EMAIL AND NO FURTHER COMMENTS FROM U S EPA REGION III ON BTAG NWS
YORKTOWN VA
12/04/2013
U S EPA REGION III

From: [Oduwole, Moshood](#)
To: [Friedmann, William/VBO](#)
Cc: Wade.Smith@deq.virginia.gov; james.gravette@navy.mil; [Yarberry, Kim-Lee/ATL](#)
Subject: RE: Site 34 Navy Response to BTAG Comments
Date: Wednesday, December 04, 2013 2:07:44 PM
Attachments: [image001.png](#)
[image002.png](#)

From: William.Friedmann@CH2M.com [<mailto:William.Friedmann@CH2M.com>]
Sent: Friday, November 22, 2013 3:19 PM
To: Oduwole, Moshood
Cc: Wade.Smith@deq.virginia.gov; james.gravette@navy.mil; Kim-Lee.Yarberry@ch2m.com
Subject: Site 34 Navy Response to BTAG Comments

Figure 8
Proposed Soil and Sediment Sample Locations
Site 34 SAP
Naval Weapons Station Yorktown
Yorktown, Virginia

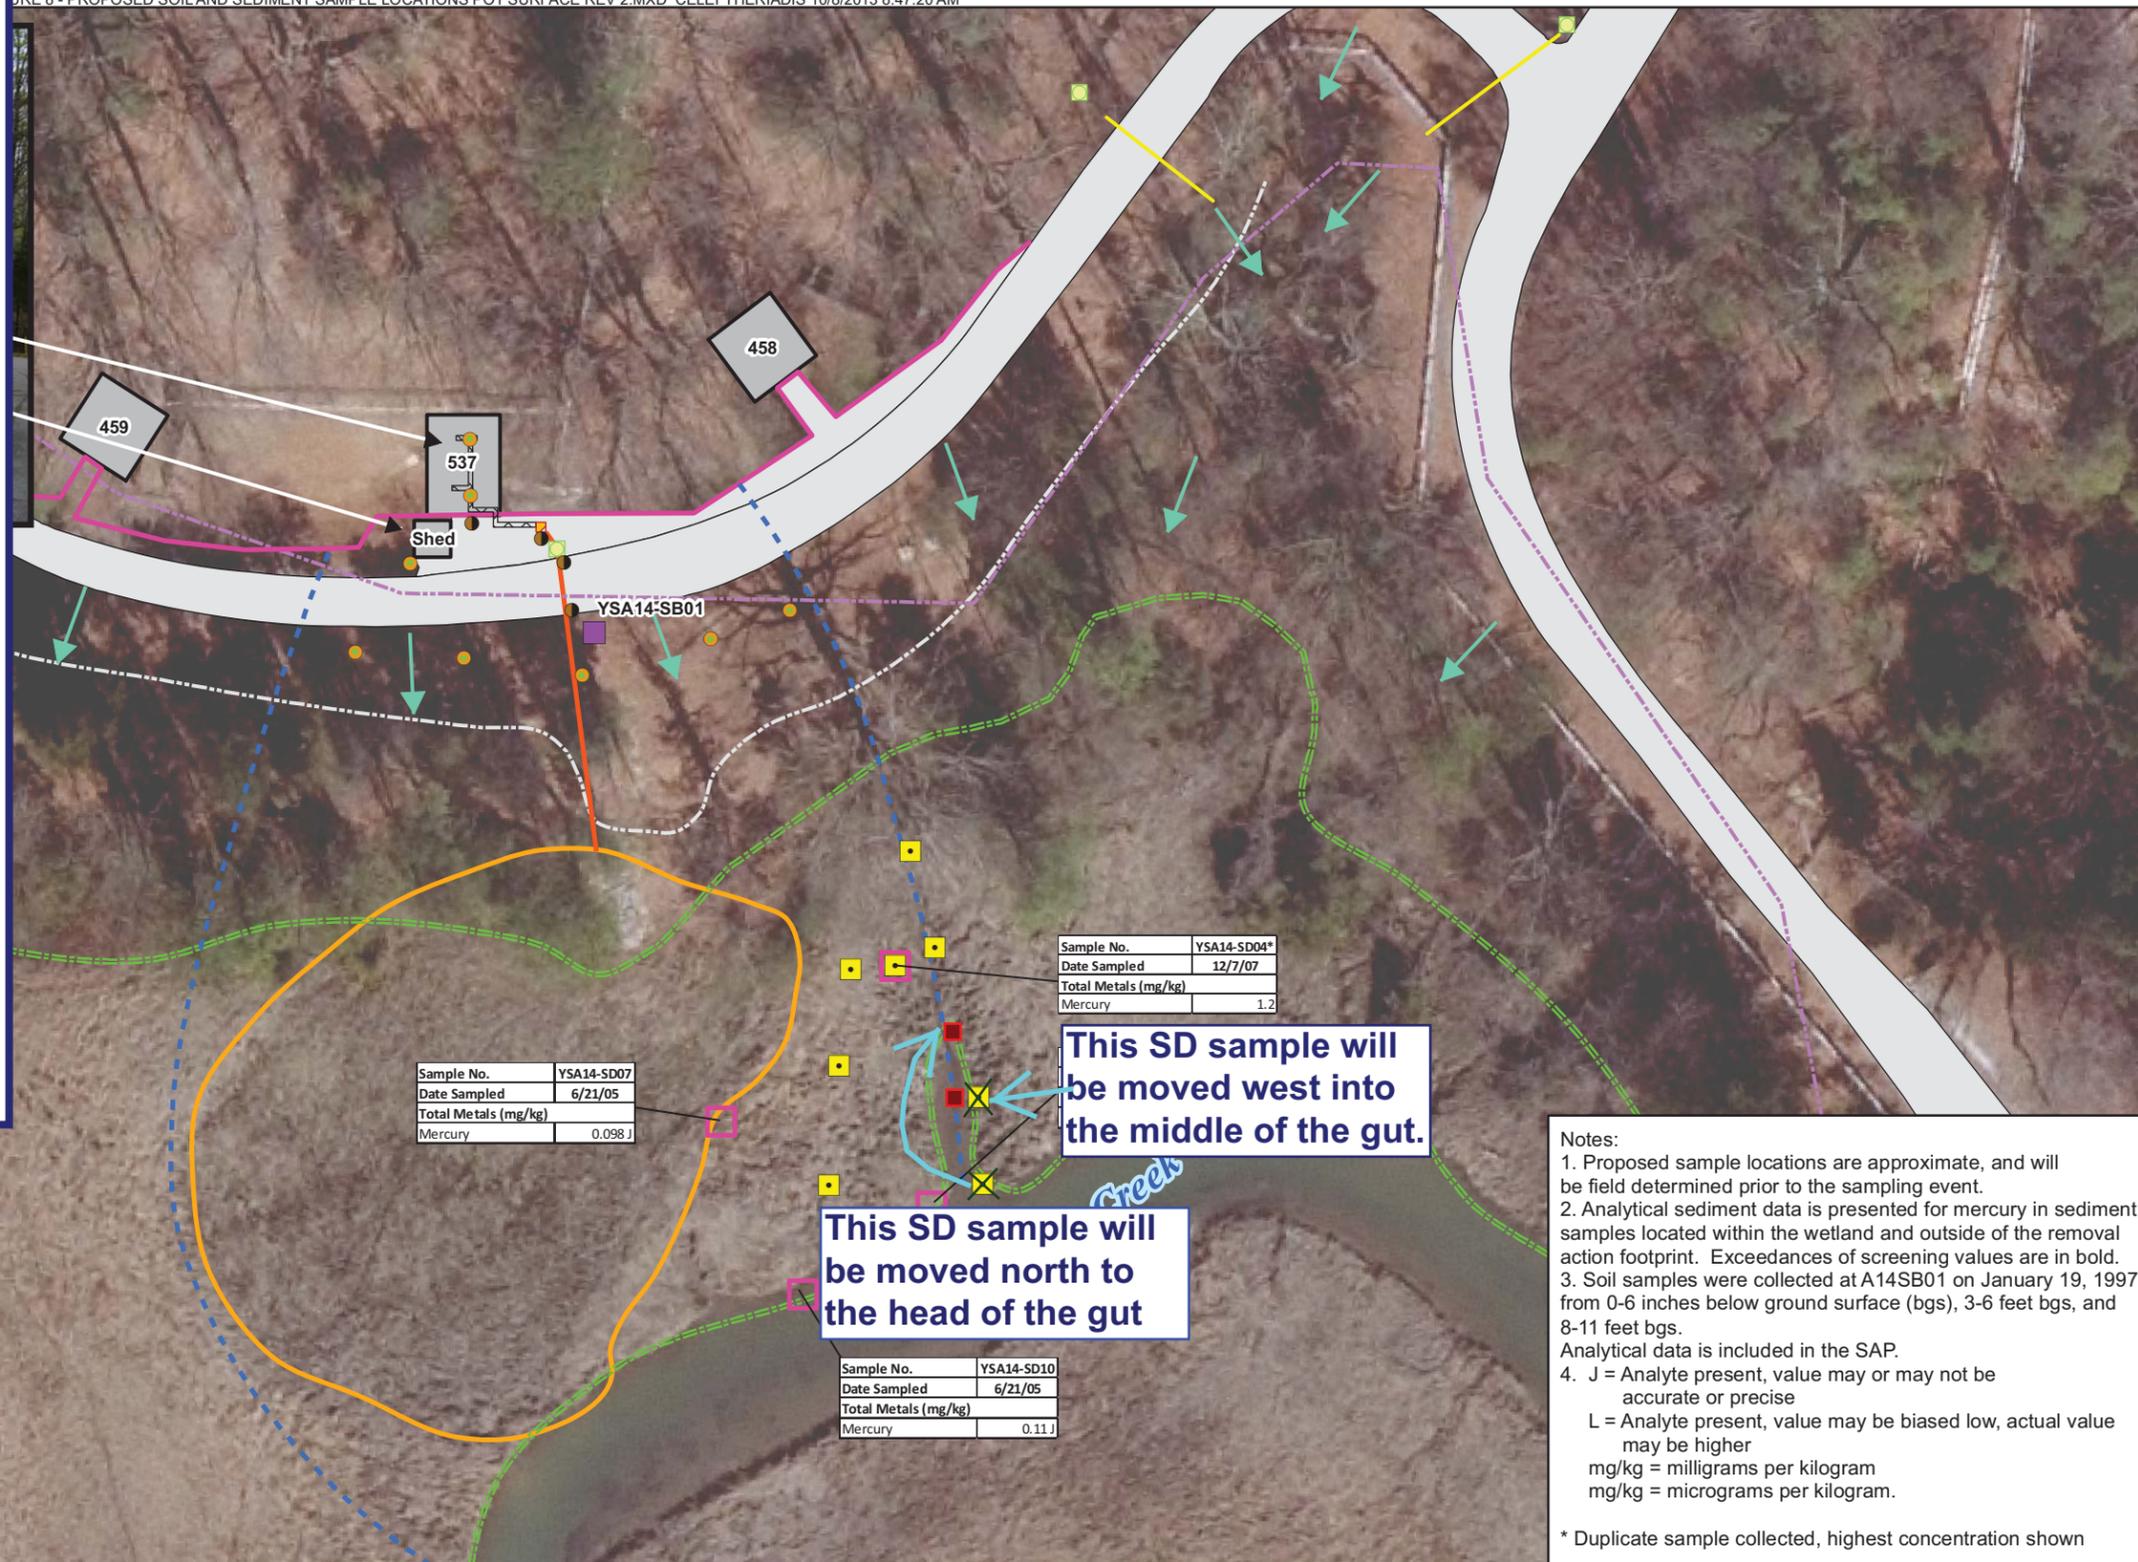
Revised Figure 8: In the gut that extends from Felgates Creek toward Building 468, the two samples need to be in the gut and not on the edge of the gut. Also, the sample located at the foot of the gut needs to be moved to the head of the gut.

The two proposed sediment samples adjacent to the gut will be re-located as suggested.

Figure 8
Proposed Soil and Sediment Sample Locations
Site 34 SAP
Naval Weapons Station Yorktown
Yorktown, Virginia

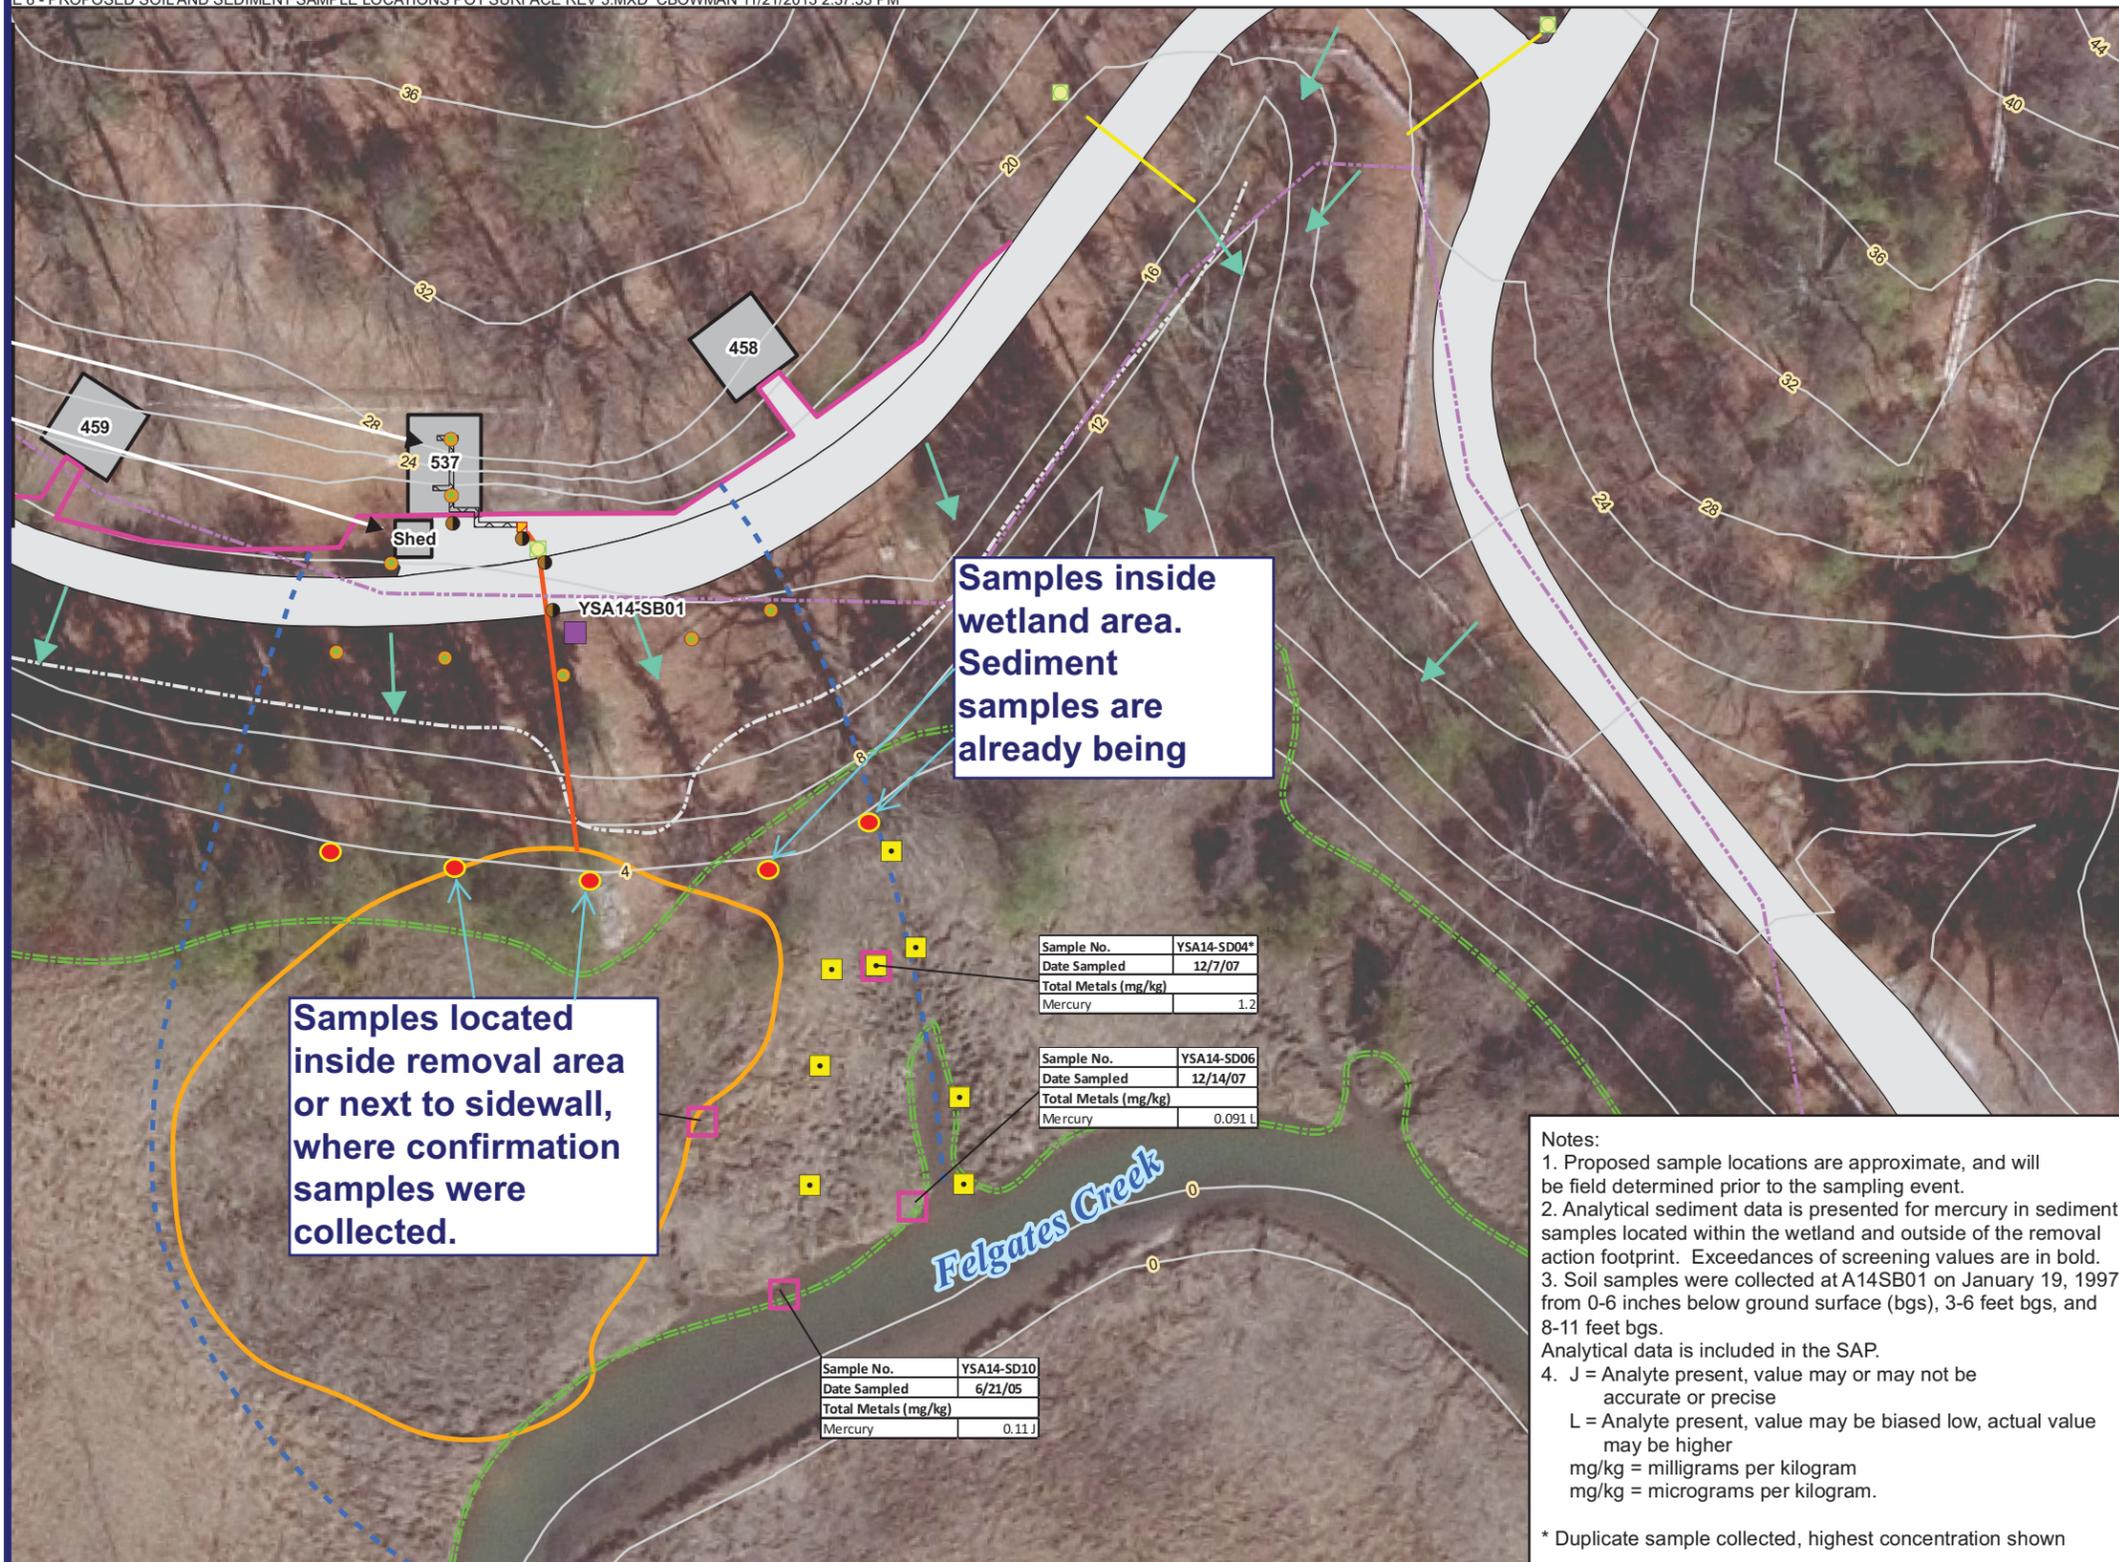
The five soil samples on the slope between Building 657 and the wetland may not be in the most advantageous locations. This appears to be a steep slope and a better place for these samples would be at the toe of the slope. These samples should be relocated.

No change in soil sample location is proposed for the following reasons:

1. If moved, two of the soil locations would be located within the removal area or along the removal area boundary, where confirmation wall samples were collected. Therefore, any contaminants which may migrated to this area have been removed.
2. If moved, two other soil locations would be located within the wetland area, which is being evaluated by proposed sediment samples.
3. The objective of the soil portion of the data gap investigation is to confirm soil contamination is not present in the vicinity of Building 537 and its associated piping that could present a source to groundwater, thereby impacting remedy effectiveness. Moving the location of the soil samples would not adequately meet this objective.
